Site Accessibility Evaluation

Americans with Disabilities Act Title II (Public Services: State and Local Government)

Sahwatch Parking Garage

Accessibility Evaluation

Finding: 1

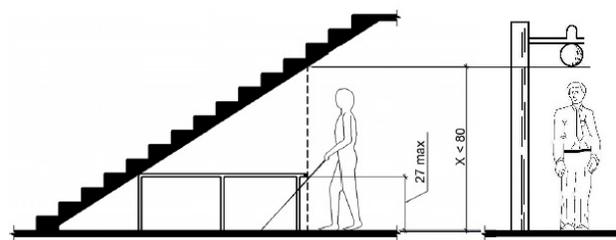
The “Stair to 1 West” overhanging sign extends down too close to the route of travel.

Any obstruction that overhangs a route of travel must be a minimum of 80 inches above the walking surface as measured from the bottom of the obstruction.

75.5 inches above
finished floor

Adjust overhanging sign to provide a minimum of 80 inches above the walking surface measured from the bottom edge of the sign.

Finding: 2

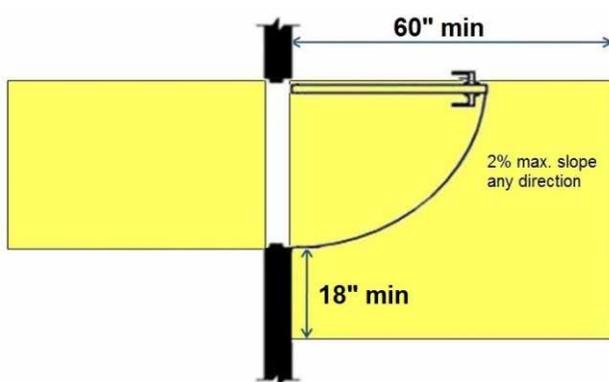
The maneuvering space on the pull side of the door or gate does not adequately extend beyond the latch side of the door.

Maneuvering space for doors or gates on the pull side with a front approach must be flat (2% max. slope in any direction) for a minimum distance of 60 inches in the direction of travel. The width of the maneuvering space must be as wide as the door or gate plus an additional 18 inches on the latch side. This latch side clearance must also be flat (2% max. slope in any direction) and clear of obstructions.

Citation:	As Built:	Budgeting Range:
2010 ADAS Section: 404.2.4.1	12 inches of maneuvering space on the pull side	\$2,500 - \$2,765.00

Providing the minimum required maneuvering space on the pull side of the door is technically infeasible at this time because existing structural conditions would require removing or altering a load-bearing member that is an essential part of the structural frame; or because other existing physical or site constraints prohibit modification or addition of elements, spaces, or features that are in full and strict compliance with the minimum requirements. Best practice measures are recommended to ensure parking garage is accessible to the maximum extent possible.

Finding: 3

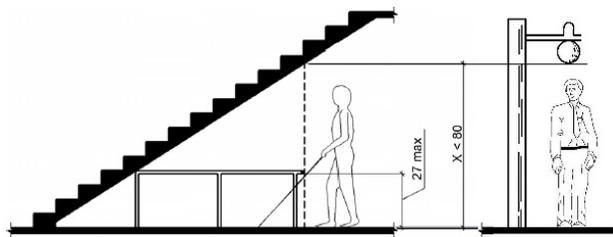
The “Stair to 2 West” overhanging sign extends down too close to the route of travel.

Any obstruction that overhangs a route of travel must be a minimum of 80 inches above the walking surface as measured from the bottom of the obstruction.

77 inches above
finished floor

Adjust overhanging sign to provide a minimum of 80 inches above the walking surface measured from the bottom edge of the sign.

Finding: 4

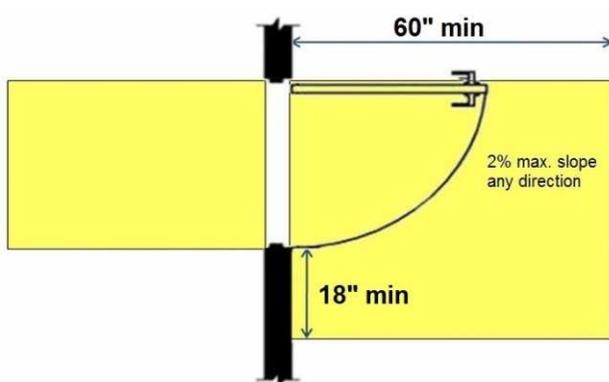
The maneuvering space on the pull side of the door or gate does not adequately extend beyond the latch side of the door.

Maneuvering space for doors or gates on the pull side with a front approach must be flat (2% max. slope in any direction) for a minimum distance of 60 inches in the direction of travel. The width of the maneuvering space must be as wide as the door or gate plus an additional 18 inches on the latch side. This latch side clearance must also be flat (2% max. slope in any direction) and clear of obstructions.

Citation:	As Built:	Budgeting Range:
2010 ADAS Section: 404.2.4.1	12 inches of maneuvering space on the pull side	\$2,500 - \$2,765.00

Providing the minimum required maneuvering space on the pull side of the door is technically infeasible at this time because existing structural conditions would require removing or altering a load-bearing member that is an essential part of the structural frame; or because other existing physical or site constraints prohibit modification or addition of elements, spaces, or features that are in full and strict compliance with the minimum requirements. Best practice measures are recommended to ensure parking garage is accessible to the maximum extent possible.

Finding: 5

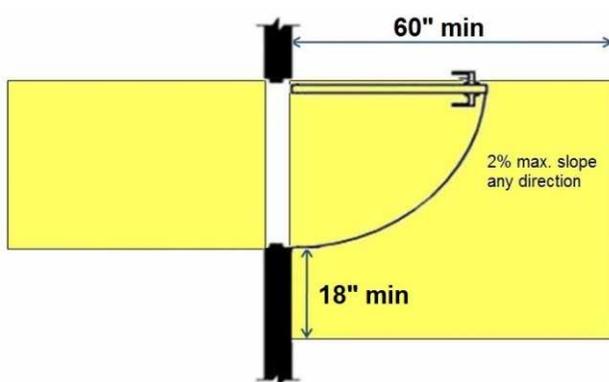
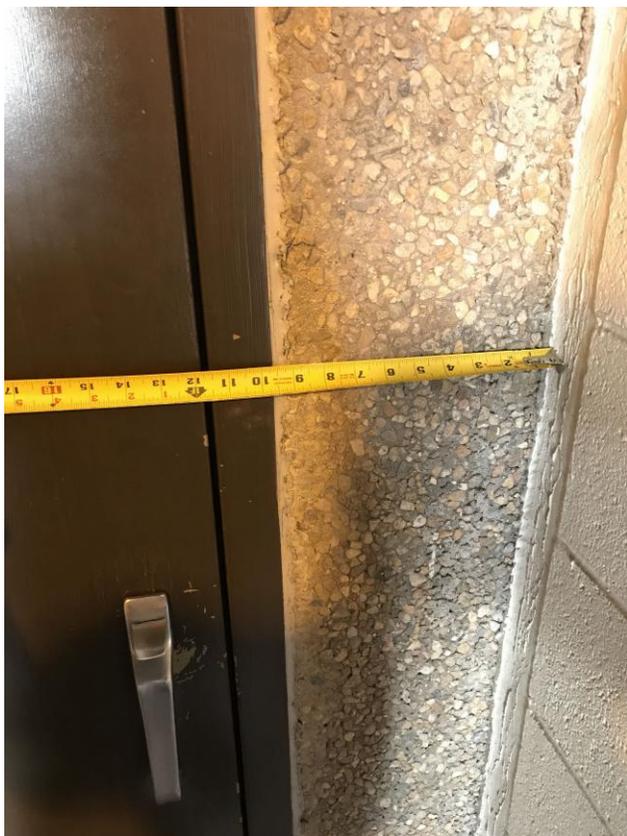
The maneuvering space on the pull side of the door or gate does not adequately extend beyond the latch side of the door.

Maneuvering space for doors or gates on the pull side with a front approach must be flat (2% max. slope in any direction) for a minimum distance of 60 inches in the direction of travel. The width of the maneuvering space must be as wide as the door or gate plus an additional 18 inches on the latch side. This latch side clearance must also be flat (2% max. slope in any direction) and clear of obstructions.

Citation:	As Built:	Budgeting Range:
2010 ADAS Section: 404.2.4.1	12 inches of maneuvering space on the pull side	\$2,500 - \$2,765.00

Providing the minimum required maneuvering space on the pull side of the door is technically infeasible at this time because existing structural conditions would require removing or altering a load-bearing member that is an essential part of the structural frame; or because other existing physical or site constraints prohibit modification or addition of elements, spaces, or features that are in full and strict compliance with the minimum requirements. Best practice measures are recommended to ensure parking garage is accessible to the maximum extent possible.

Finding: 6

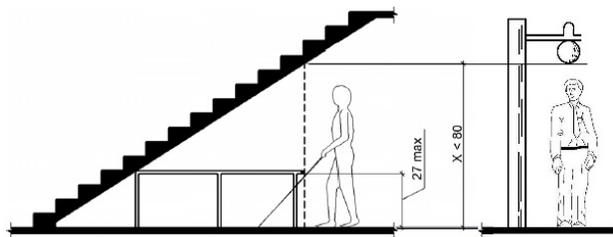
The "Stair to 3 West" overhanging sign extends down too close to the route of travel.

Any obstruction that overhangs a route of travel must be a minimum of 80 inches above the walking surface as measured from the bottom of the obstruction.

76 inches above
finished floor

Adjust overhanging sign to provide a minimum of 80 inches above the walking surface measured from the bottom edge of the sign.

Finding: 7

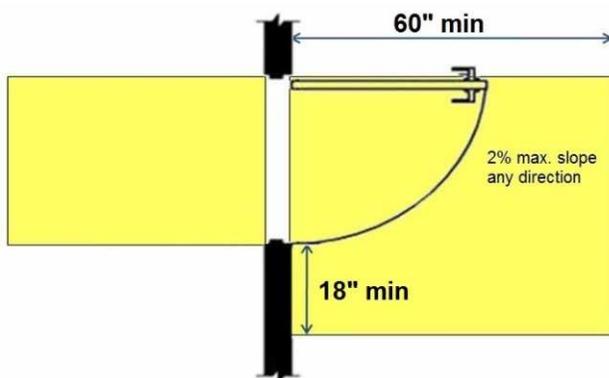
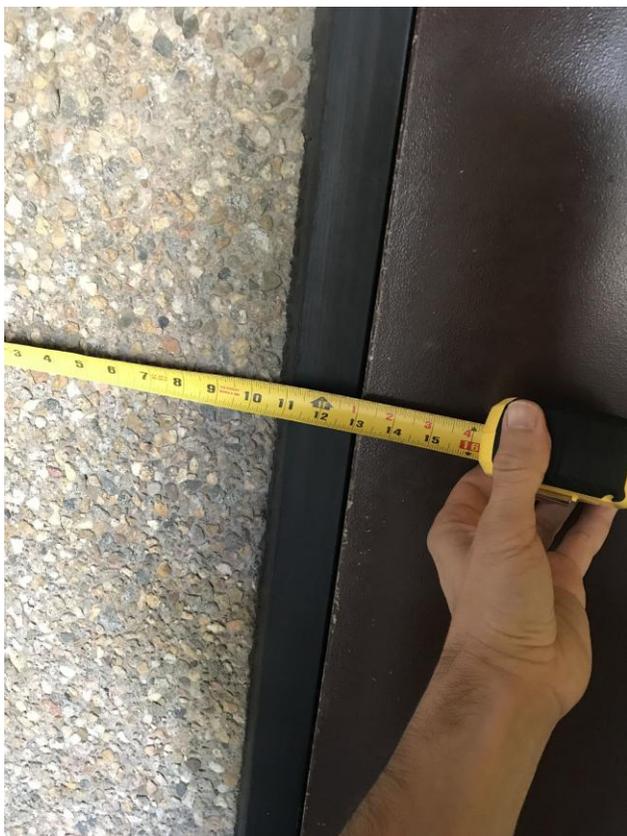
The maneuvering space on the pull side of the door or gate does not adequately extend beyond the latch side of the door.

Maneuvering space for doors or gates on the pull side with a front approach must be flat (2% max. slope in any direction) for a minimum distance of 60 inches in the direction of travel. The width of the maneuvering space must be as wide as the door or gate plus an additional 18 inches on the latch side. This latch side clearance must also be flat (2% max. slope in any direction) and clear of obstructions.

Citation:	As Built:	Budgeting Range:
2010 ADAS Section: 404.2.4.1	13 inches of maneuvering space on the pull side	\$2,500 - \$2,765.00

Providing the minimum required maneuvering space on the pull side of the door is technically infeasible at this time because existing structural conditions would require removing or altering a load-bearing member that is an essential part of the structural frame; or because other existing physical or site constraints prohibit modification or addition of elements, spaces, or features that are in full and strict compliance with the minimum requirements. Best practice measures are recommended to ensure parking garage is accessible to the maximum extent possible.

Finding: 8

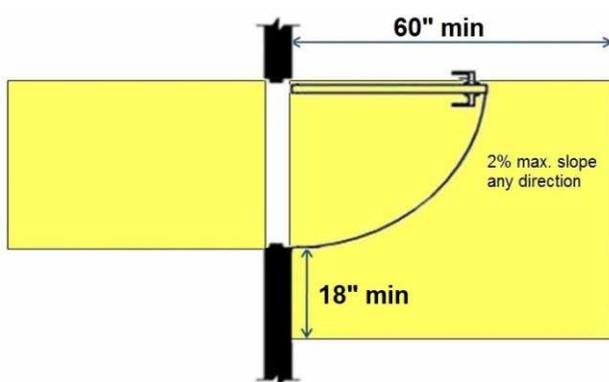
The maneuvering space on the pull side of the door or gate does not adequately extend beyond the latch side of the door.

Maneuvering space for doors or gates on the pull side with a front approach must be flat (2% max. slope in any direction) for a minimum distance of 60 inches in the direction of travel. The width of the maneuvering space must be as wide as the door or gate plus an additional 18 inches on the latch side. This latch side clearance must also be flat (2% max. slope in any direction) and clear of obstructions.

Citation:	As Built:	Budgeting Range:
2010 ADAS Section: 404.2.4.1	13 inches of maneuvering space on the pull side	\$2,500 - \$2,765.00

Providing the minimum required maneuvering space on the pull side of the door is technically infeasible at this time because existing structural conditions would require removing or altering a load-bearing member that is an essential part of the structural frame; or because other existing physical or site constraints prohibit modification or addition of elements, spaces, or features that are in full and strict compliance with the minimum requirements. Best practice measures are recommended to ensure parking garage is accessible to the maximum extent possible.

Finding: 9

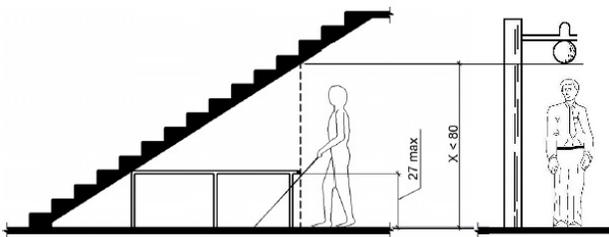
The “Stair to 4 West” overhanging sign extends down too close to the route of travel.

Any obstruction that overhangs a route of travel must be a minimum of 80 inches above the walking surface as measured from the bottom of the obstruction.

76 inches above
finished floor

Adjust overhanging sign to provide a minimum of 80 inches above the walking surface measured from the bottom edge of the sign.

Finding: 10

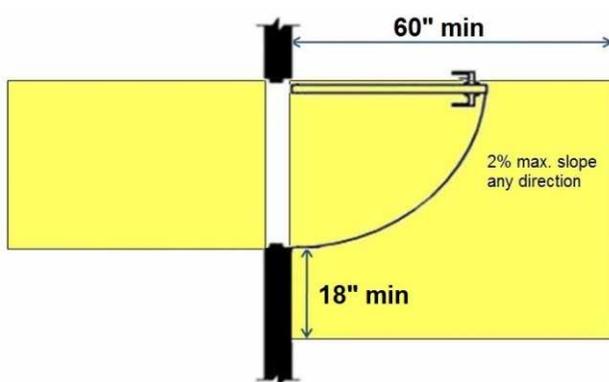
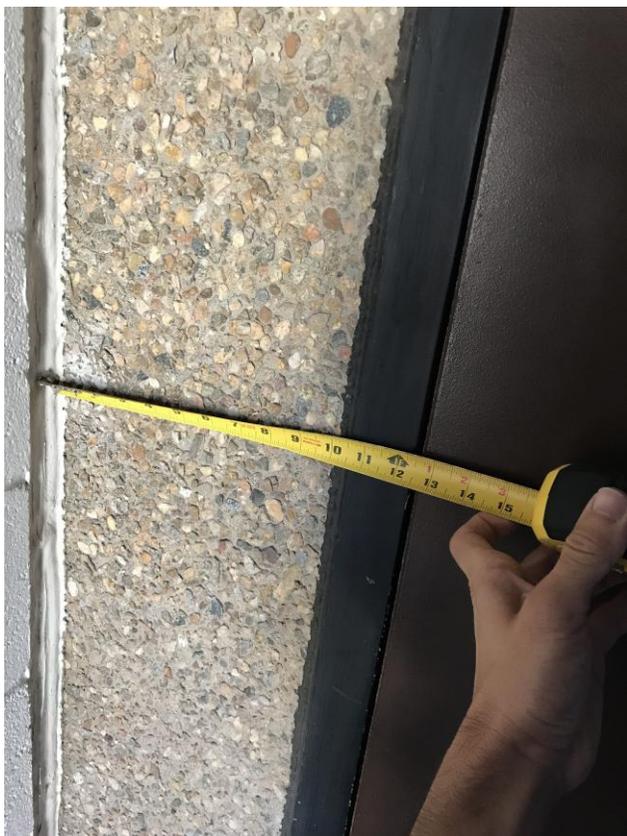
The maneuvering space on the pull side of the door or gate does not adequately extend beyond the latch side of the door.

Maneuvering space for doors or gates on the pull side with a front approach must be flat (2% max. slope in any direction) for a minimum distance of 60 inches in the direction of travel. The width of the maneuvering space must be as wide as the door or gate plus an additional 18 inches on the latch side. This latch side clearance must also be flat (2% max. slope in any direction) and clear of obstructions.

Citation:	As Built:	Budgeting Range:
2010 ADAS Section: 404.2.4.1	12.5 inches of maneuvering space on the pull side	\$2,500 - \$2,765.00

Providing the minimum required maneuvering space on the pull side of the door is technically infeasible at this time because existing structural conditions would require removing or altering a load-bearing member that is an essential part of the structural frame; or because other existing physical or site constraints prohibit modification or addition of elements, spaces, or features that are in full and strict compliance with the minimum requirements. Best practice measures are recommended to ensure parking garage is accessible to the maximum extent possible.

Finding: 11

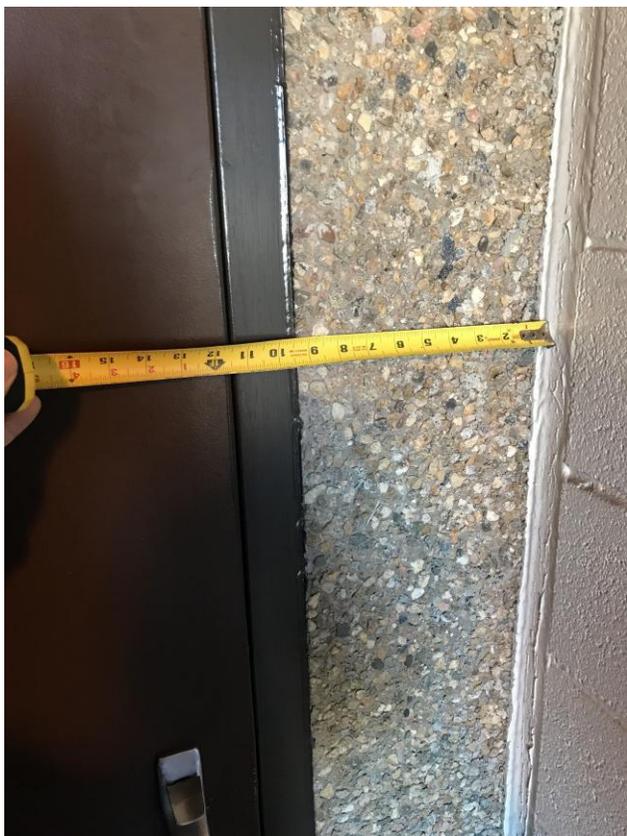
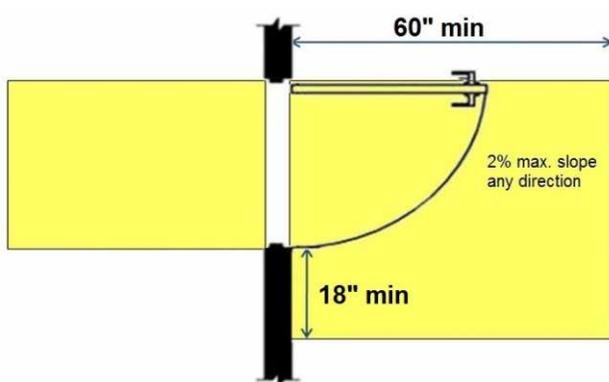
The maneuvering space on the pull side of the door or gate does not adequately extend beyond the latch side of the door.

Maneuvering space for doors or gates on the pull side with a front approach must be flat (2% max. slope in any direction) for a minimum distance of 60 inches in the direction of travel. The width of the maneuvering space must be as wide as the door or gate plus an additional 18 inches on the latch side. This latch side clearance must also be flat (2% max. slope in any direction) and clear of obstructions.

Citation:	As Built:	Budgeting Range:
2010 ADAS Section: 404.2.4.1	11.5 inches of maneuvering space on the pull side	\$2,500 - \$2,765.00

Providing the minimum required maneuvering space on the pull side of the door is technically infeasible at this time because existing structural conditions would require removing or altering a load-bearing member that is an essential part of the structural frame; or because other existing physical or site constraints prohibit modification or addition of elements, spaces, or features that are in full and strict compliance with the minimum requirements. Best practice measures are recommended to ensure parking garage is accessible to the maximum extent possible.

Finding: 12

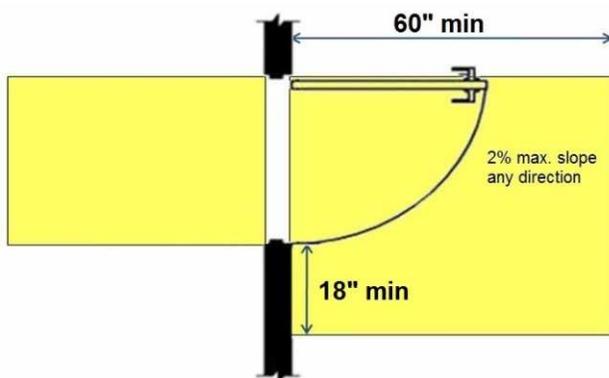
The maneuvering space on the pull side of the door or gate does not adequately extend beyond the latch side of the door.

Maneuvering space for doors or gates on the pull side with a front approach must be flat (2% max. slope in any direction) for a minimum distance of 60 inches in the direction of travel. The width of the maneuvering space must be as wide as the door or gate plus an additional 18 inches on the latch side. This latch side clearance must also be flat (2% max. slope in any direction) and clear of obstructions.

Citation:	As Built:	Budgeting Range:
2010 ADAS Section: 404.2.4.1	12.5 inches of maneuvering space on the pull side	\$2,500 - \$2,765.00

Providing the minimum required maneuvering space on the pull side of the door is technically infeasible at this time because existing structural conditions would require removing or altering a load-bearing member that is an essential part of the structural frame; or because other existing physical or site constraints prohibit modification or addition of elements, spaces, or features that are in full and strict compliance with the minimum requirements. Best practice measures are recommended to ensure parking garage is accessible to the maximum extent possible.

Finding: 13

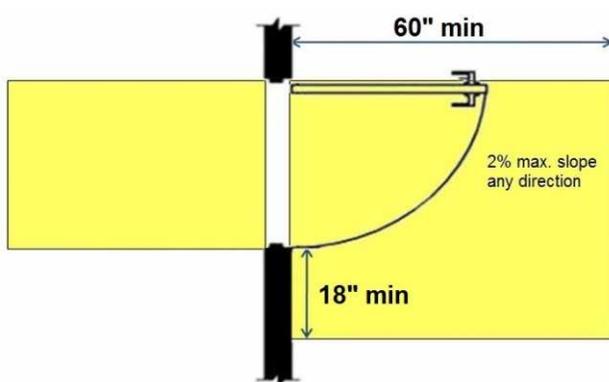
The maneuvering space on the pull side of the door or gate does not adequately extend beyond the latch side of the door.

Maneuvering space for doors or gates on the pull side with a front approach must be flat (2% max. slope in any direction) for a minimum distance of 60 inches in the direction of travel. The width of the maneuvering space must be as wide as the door or gate plus an additional 18 inches on the latch side. This latch side clearance must also be flat (2% max. slope in any direction) and clear of obstructions.

Citation:	As Built:	Budgeting Range:
2010 ADAS Section: 404.2.4.1	12 inches of maneuvering space on the pull side	\$2,500 - \$2,765.00

Providing the minimum required maneuvering space on the pull side of the door is technically infeasible at this time because existing structural conditions would require removing or altering a load-bearing member that is an essential part of the structural frame; or because other existing physical or site constraints prohibit modification or addition of elements, spaces, or features that are in full and strict compliance with the minimum requirements. Best practice measures are recommended to ensure parking garage is accessible to the maximum extent possible.
